This meeting of the Grimes Planning and Zoning Commission was called to order Tuesday December 3, 2019 at 5:30 P.M. at Grimes City Hall.

The Development Services Department is in receipt of a proposed Site Plan for Project Viking. Based on the review of the provided submittal materials, staff have the following comments:

SITE PLAN FOR: PROJECT VIKING

The Development Services Department is in receipt of a proposed Site Plan for Destination Market Plat 3. Based on the review of the provided submittal materials, staff have the following comments:

TSB #1 - TEMPORARY STAND PIPE DETAIL

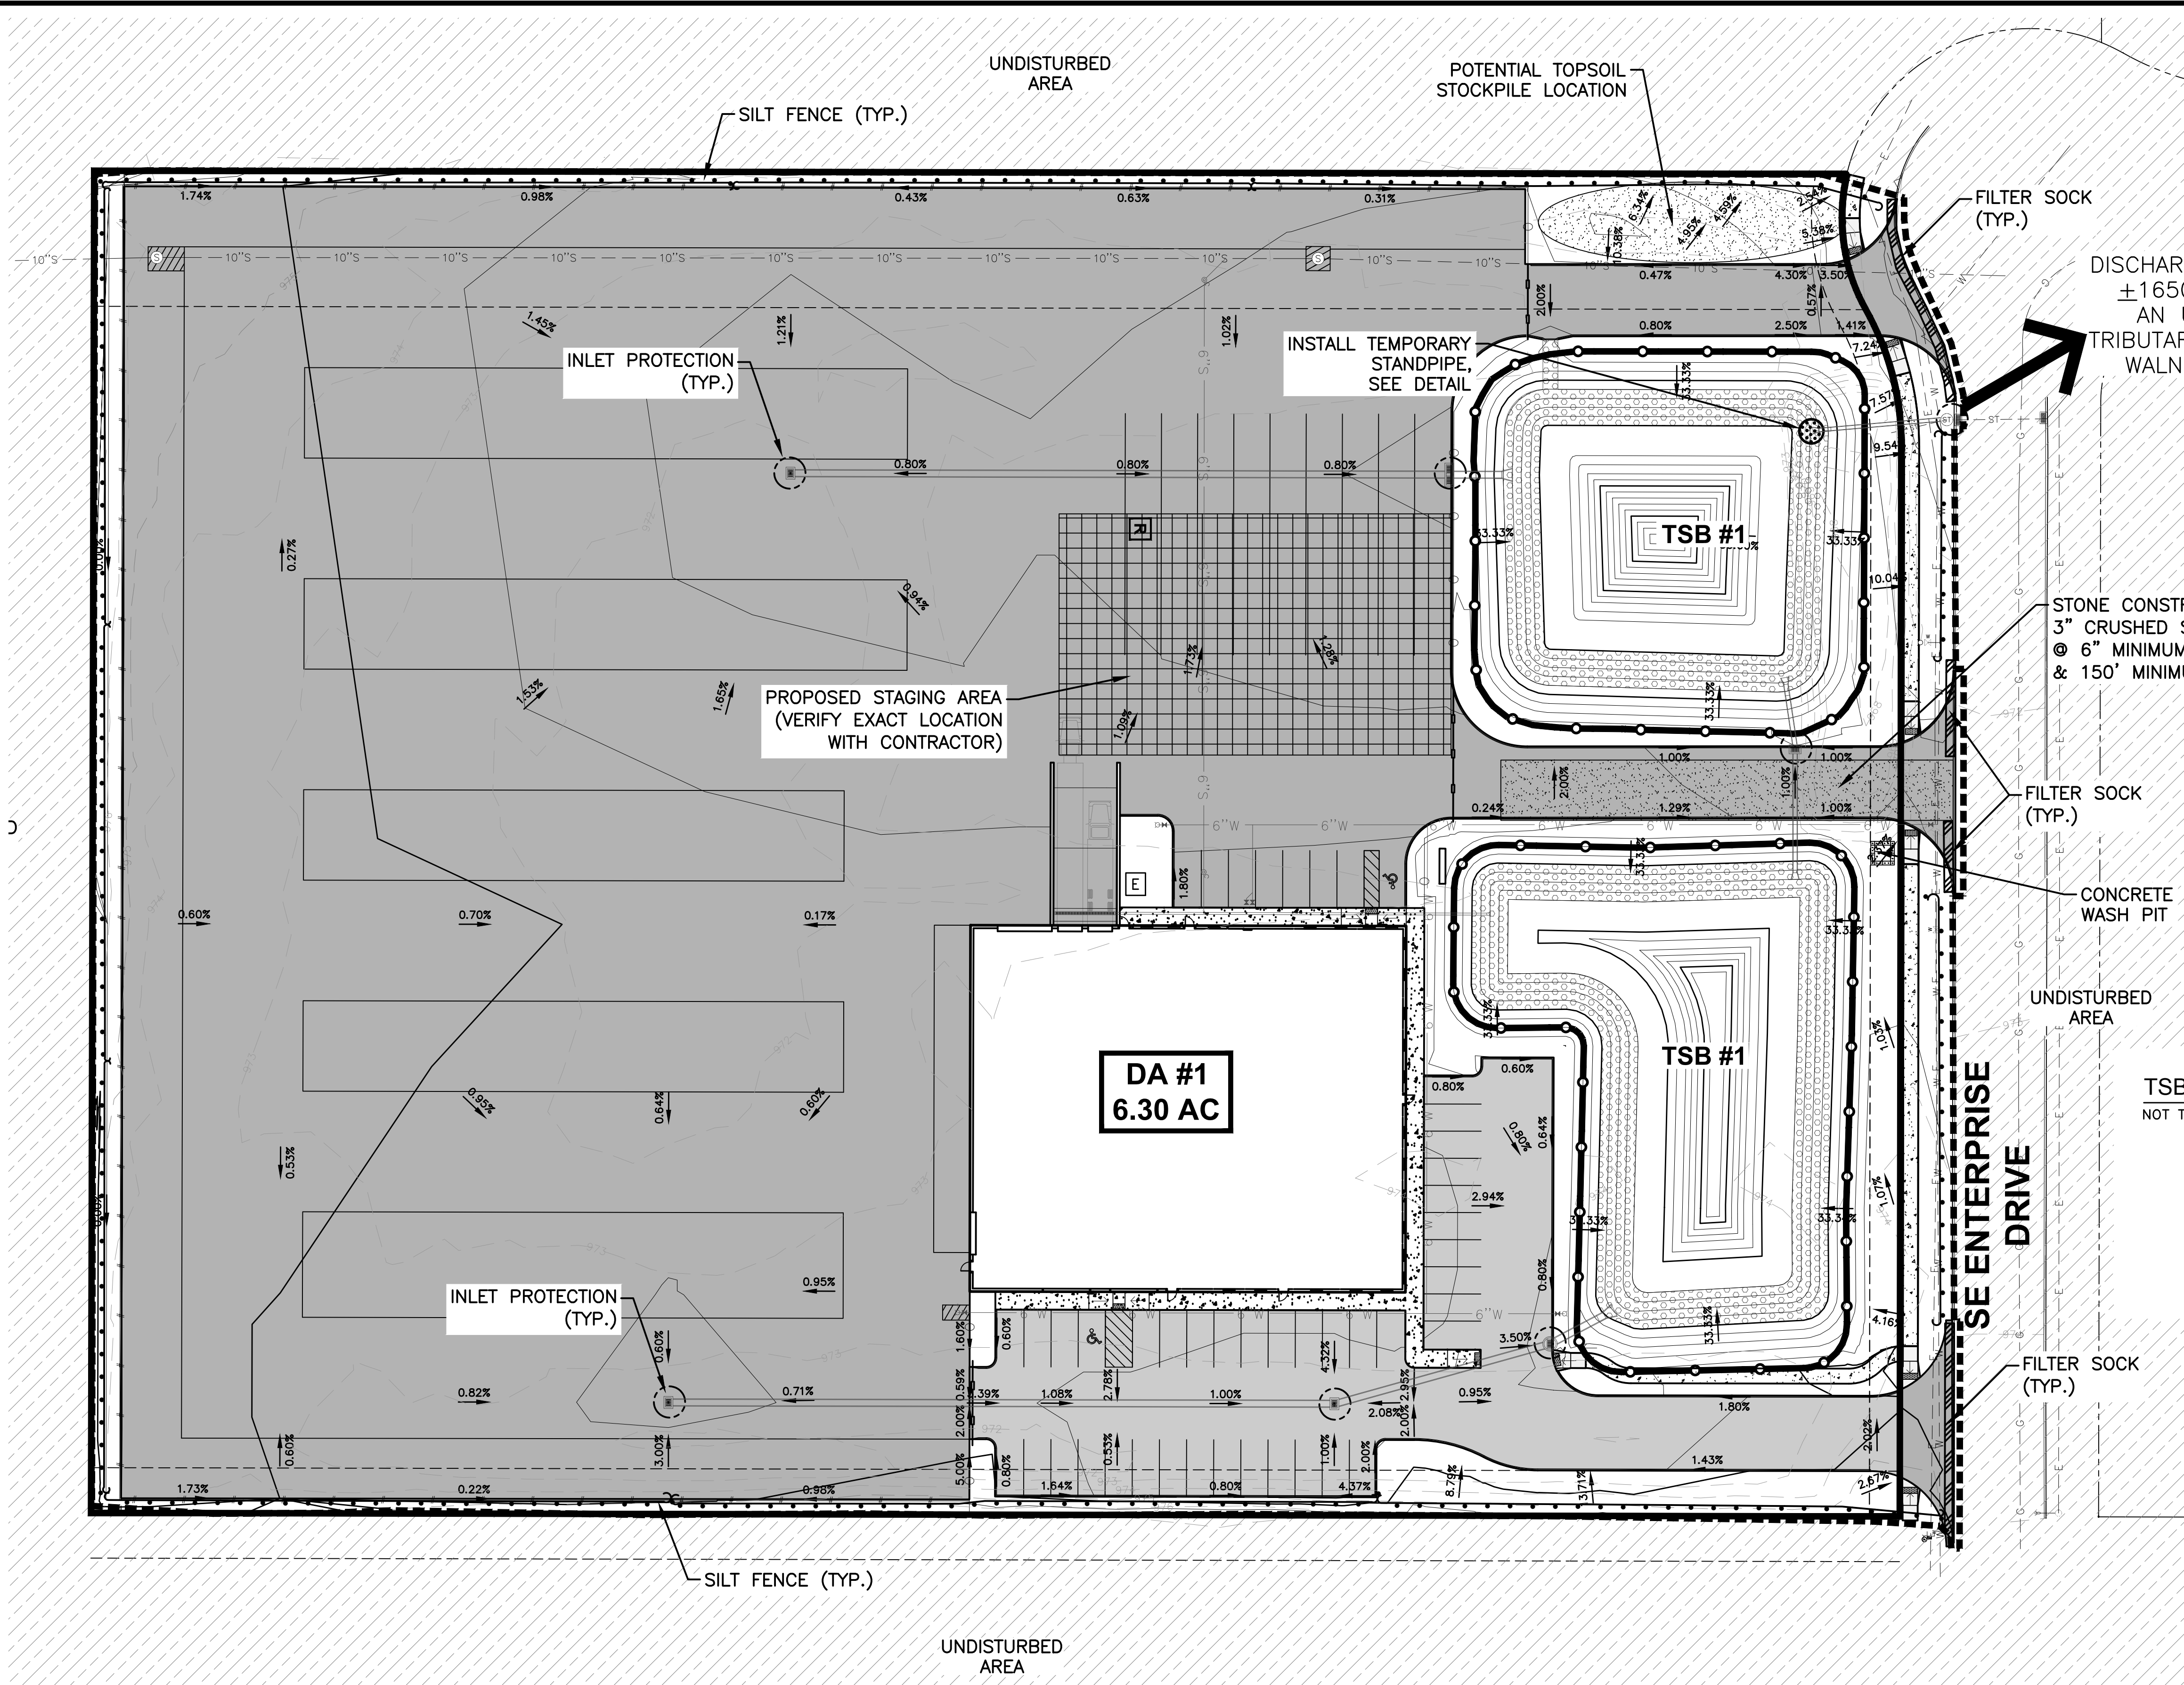
31. Add Please comment as to whether the temporary standpipe will be open or closed top.
32. Please add comment about capturing PCC sawcutting slurry/grinding dust.

UTILITY PLAN

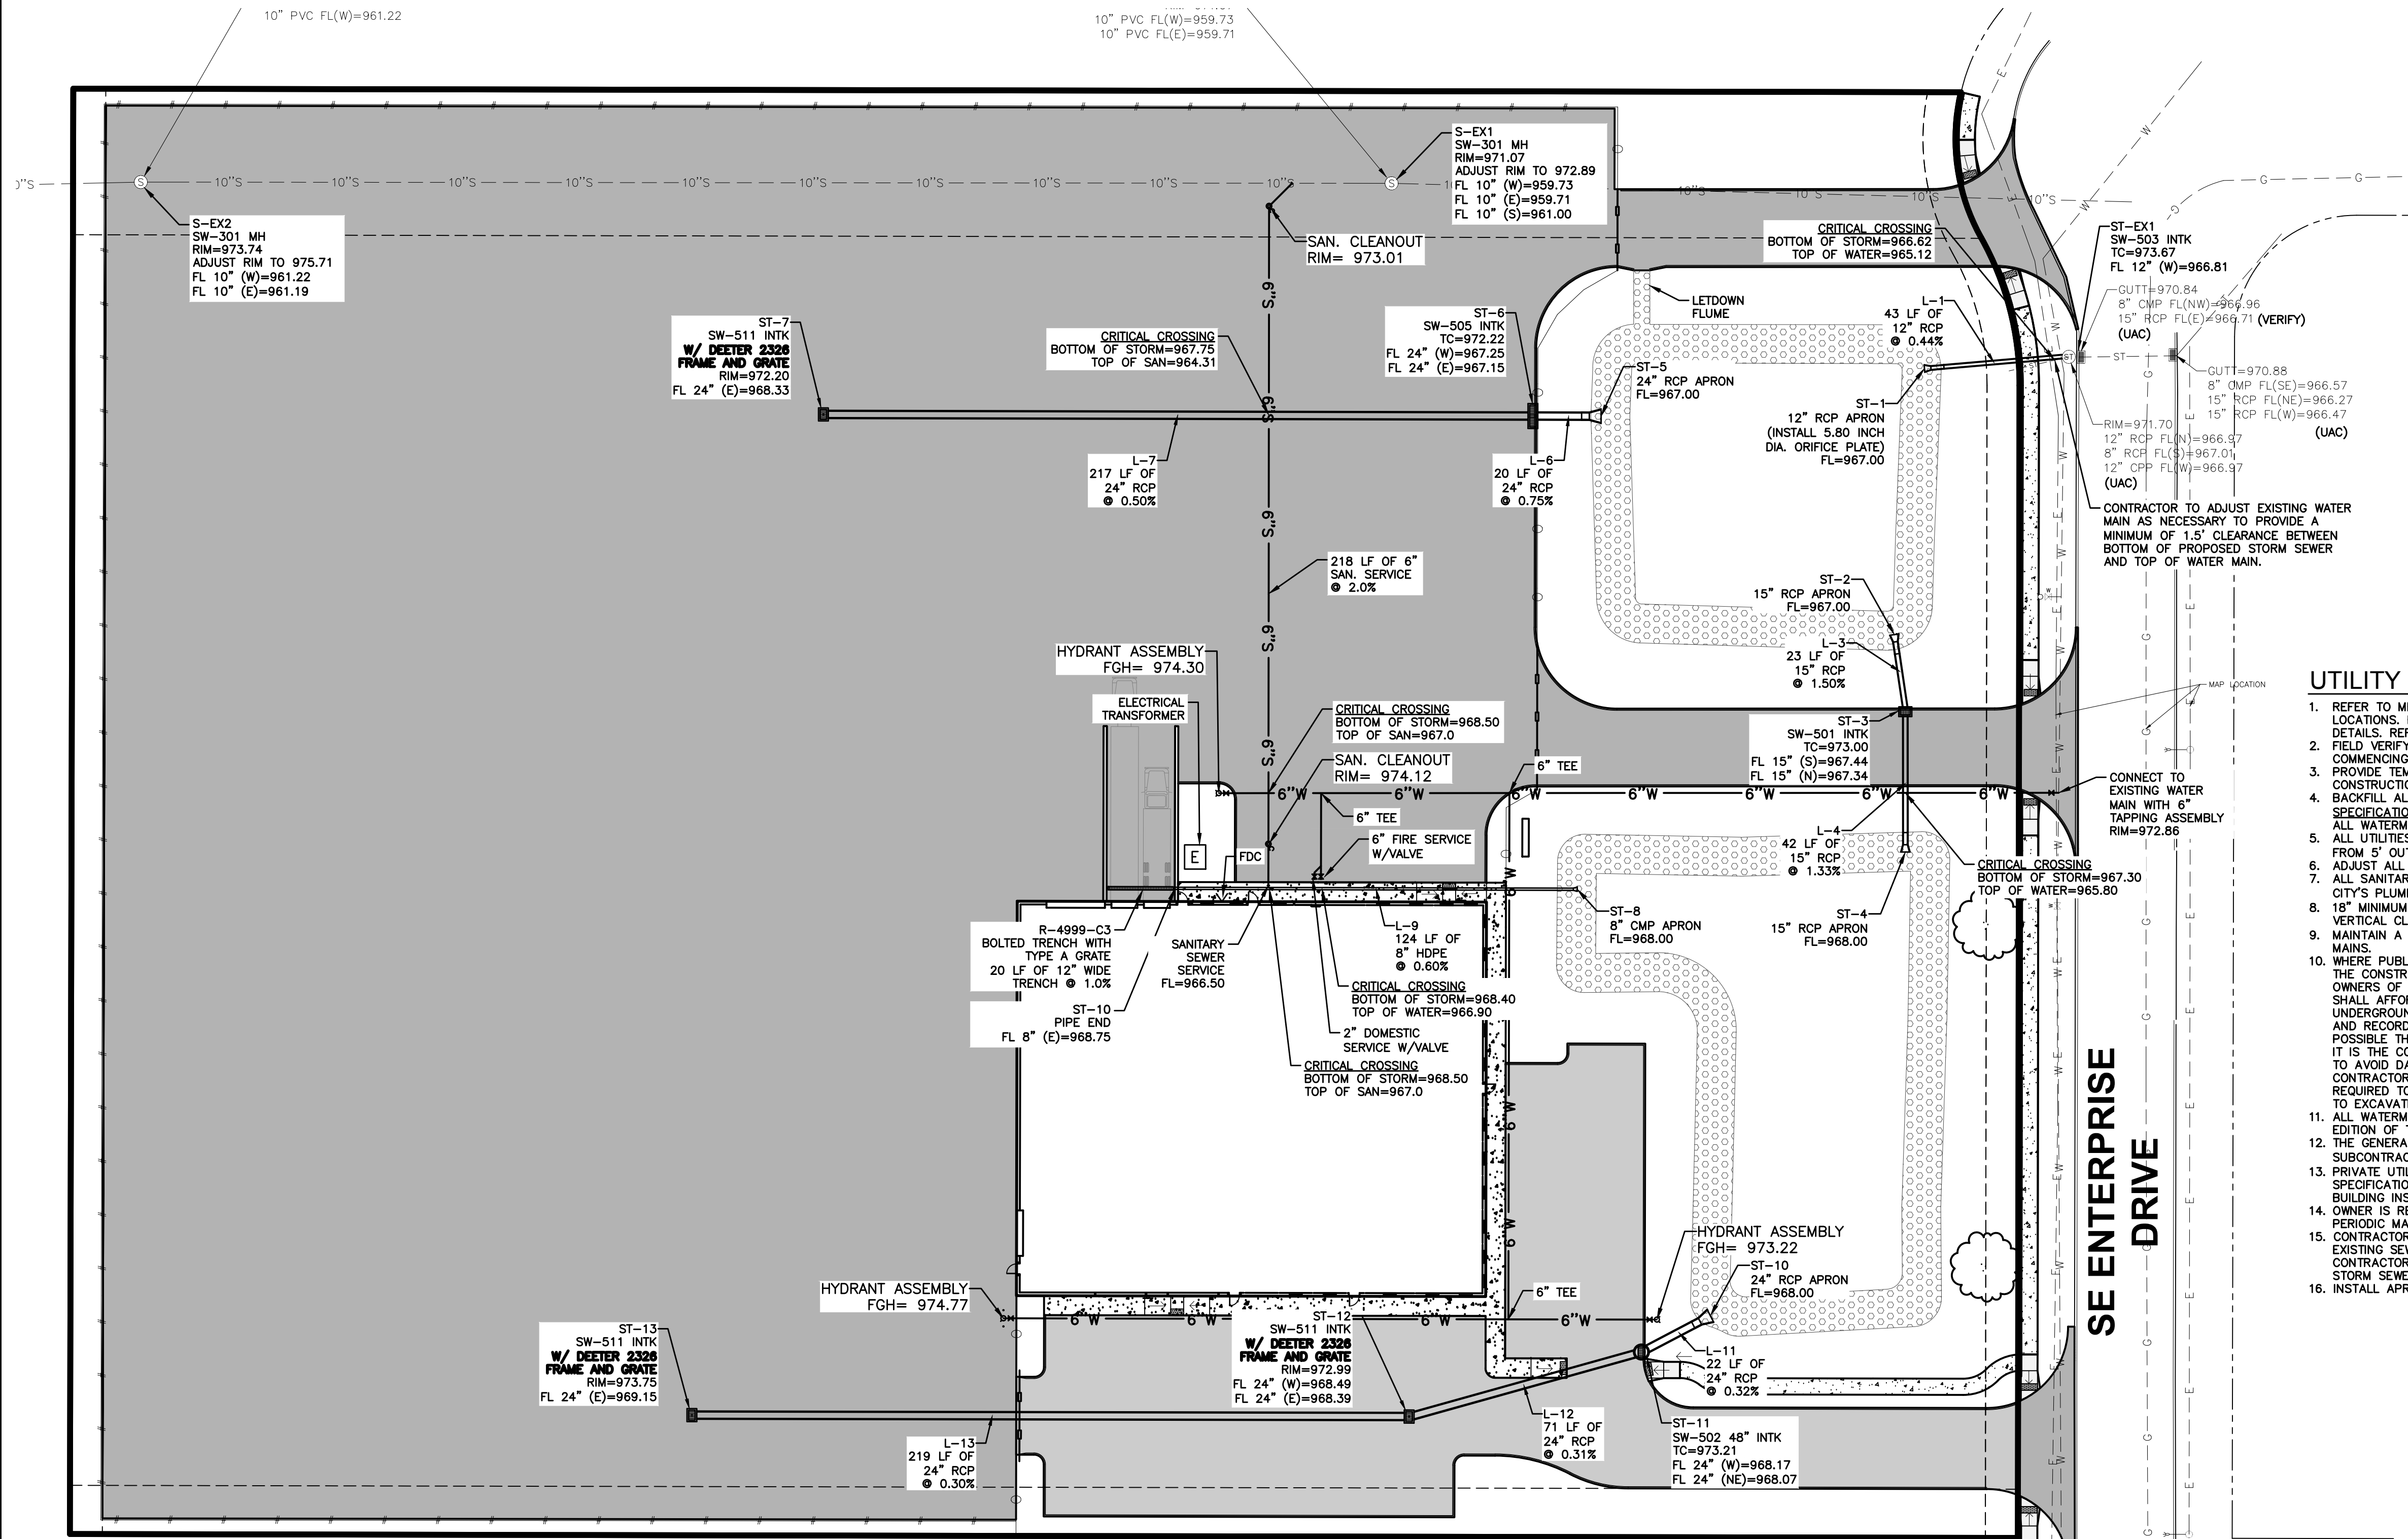
33. Please show all existing utilities on site.

34. Please show the sanitary sewer connection into the manhole, and provide flowline/rim data. ~~Staff mistakenly typed this. The service connection cannot be made into the manhole. Please adjust with a wye connection.~~

37. Note that given the ability to provide for high pile storage, it is unlikely that the 6" service line will provide enough pressure to supply the system. A fire pump may be required.

38. Please provide hydrants in a manner that allows all areas of the building to be accessed along a 150-foot route path from the site hydrants. ~~Addition hydrant coverage is necessary for the other sides of the building. As shown, no hydrant access is available to the east, south and west sides.~~
